RE: Re-submittal Form C-108, Application for Authorization to Inject
Tomcat 15 Federal #2; API# 30-025-33909
Lea County, NM
Section 15, T23S, R32E

From: Jones, William V., EMNRD
Sent: Tuesday, July 15, 2008 12:52 PM
To: 'Slack, Ronnie'
Cc: Ezeanyim, Richard, EMNRD; Warnell, Terry G, EMNRD
Subject: Injection Application from Devon: Tomcat 15 Federal #2 30-025-33909 Unit J Sec 15 T23S R32E

From: Wesley_Ingram@blm.gov
Sent: Friday, September 26, 2008 5:51 PM
To: Shannon_Shaw@nm.blm.gov
Cc: Jones, William V., EMNRD
Subject: Re: Conversion of Tomcat 15 Fed 2

Well Name: CODORNIZ FEDERAL #2		Field: DIAMOND TAIL	
Location: 1850' FNL & 330' FEL; SEC 15-T23S-R32E		County: LEA	State: NM
Elevation: 3720' GL		Spud Date: 5/30/95	Compl Date: P&A 6/19/95
API#: 30-025-32972	Prepared by: Ronnie Slack	Date: 5/12/08	Rev:

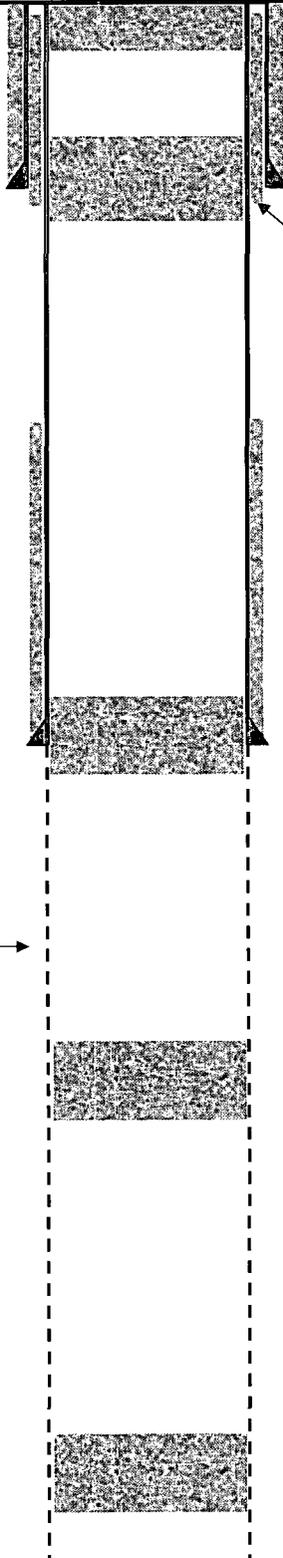
- 1) It appears that one well in the AOR does not isolate the injection adequately
Please ask your people if they would rather re-enter and re-plug the 30-025-32972 (Codorniz Federal #2 - STRATA) to isolate the proposed injection interval OR you could revise your C-108 and send new notices and newspaper notice - applying to inject from 5126 to 7042.
(interval between plugs in the Codorniz well).
- 2) Please send a copy of the CBL or Temp Survey run on the 5-1/2 inch casing to Hobbs to be included in the imaged well logs.
- 3) Ask your Geologist what is the formation names and tops from depths of 1340 feet to 5000 feet.

Our requested injection zone in the Tomcat 15 Fed #2 is the Bell Canyon from 5207' to 5530'. The Codorniz Fed #2 (operated by Strata) well that is plugged, has a cement plug from 5026 to 5126 (across the 8-5/8" casing shoe). In addition there is cement behind the 8-5/8 shoe up to 4000' w/ two more cement plugs above this. There are plugs below our proposed injection interval in the Codorniz well at 7042-7142 & 8736-8836'. It appears to me that our proposed injection interval is being capped from top & bottom by these plugs in this offset well. I have attached the schemat of the Codorniz Fed #2 plugged well & our Tomcat 15 Fed #2. I do not know if it would be in our interest/feasible to re-enter Strata's well and plug further.

COMPANY JOHN H. TRIGG
WELL FEDERAL CONTINENTAL 1-15
FIELD WILDCAT
COUNTY LEA STATE NEW MEXICO

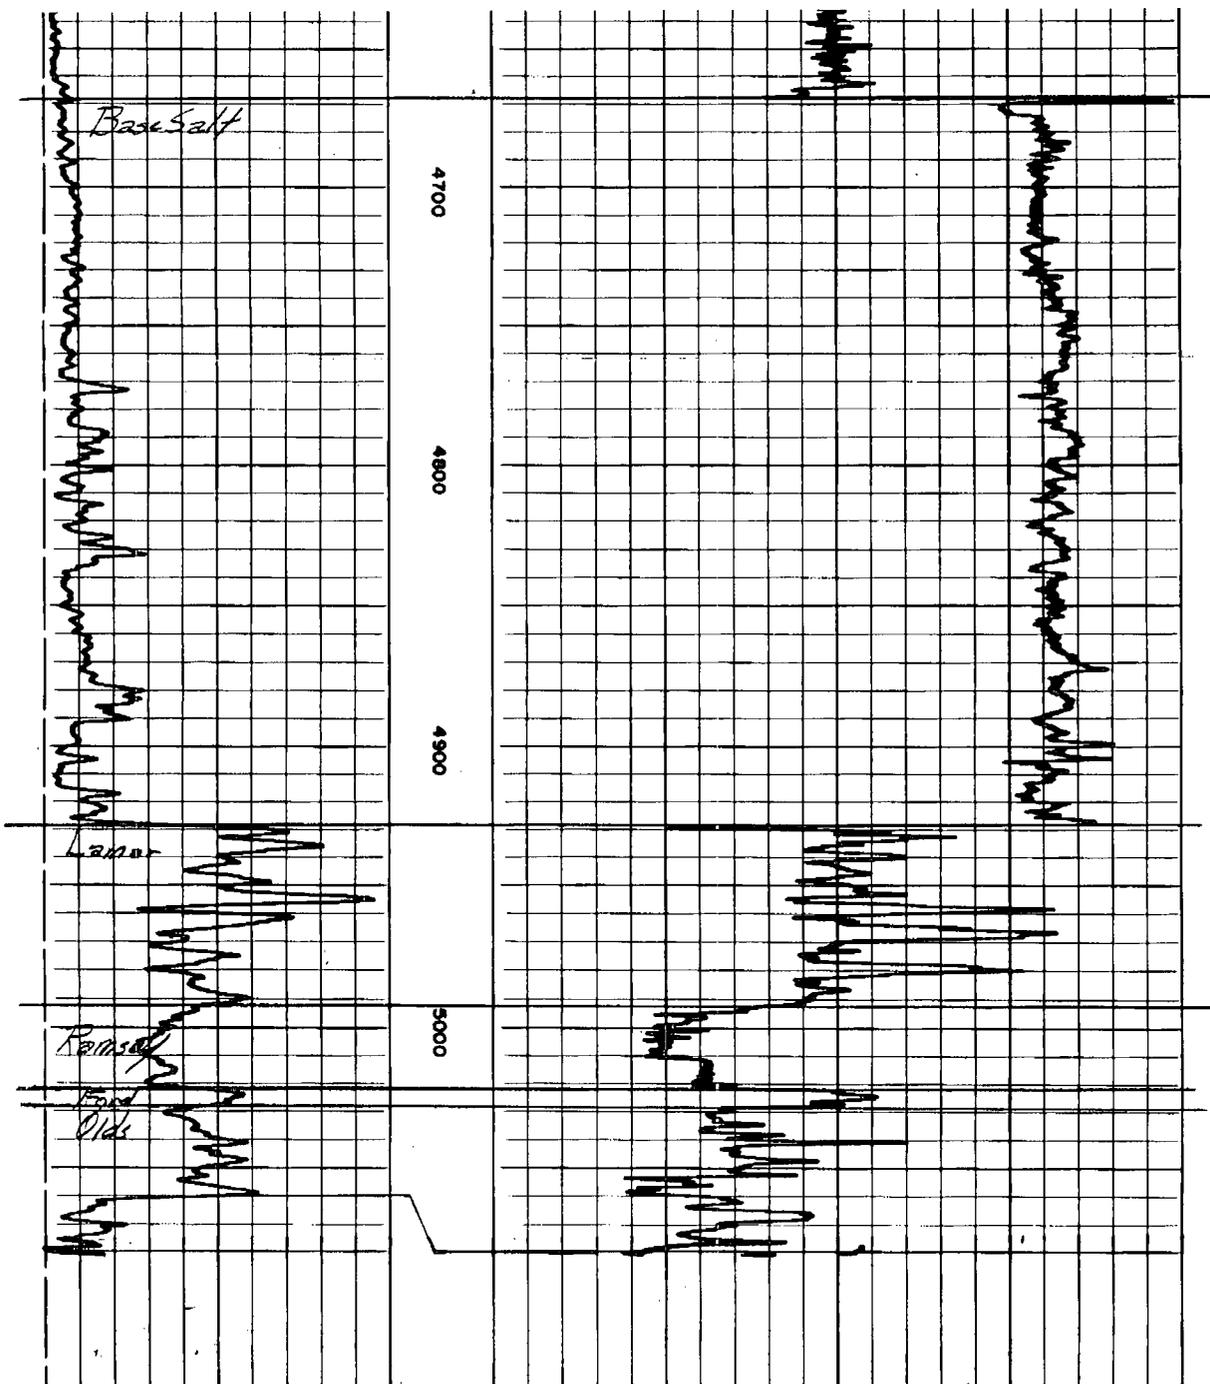
1. The John H. Trigg well - Continental Fed 1-15 has no recorded history of plugging operations and could be a potential problem. If the formation allows fluid to travel throughout, which appears to be the assumption with regards to the change in the application due to the plugged Codorniz Fed 2 well, there is a possibility that flow will enter this wellbore.
2. Also with the expanded range to encompass more of the Delaware due to the Codorniz Fed 2, there is also the possibility that flow could work up the formation and past the TOC on this proposed injection well since the top of the Bell Canyon is 5000' and the TOC is 5130'.

? POORLY? PLUGGED well

The following are recommended actions - confirm that the Trigg well is adequately plugged and perform a bull head squeeze on the Tomcat to tie the production casing back to the intermediate casing.
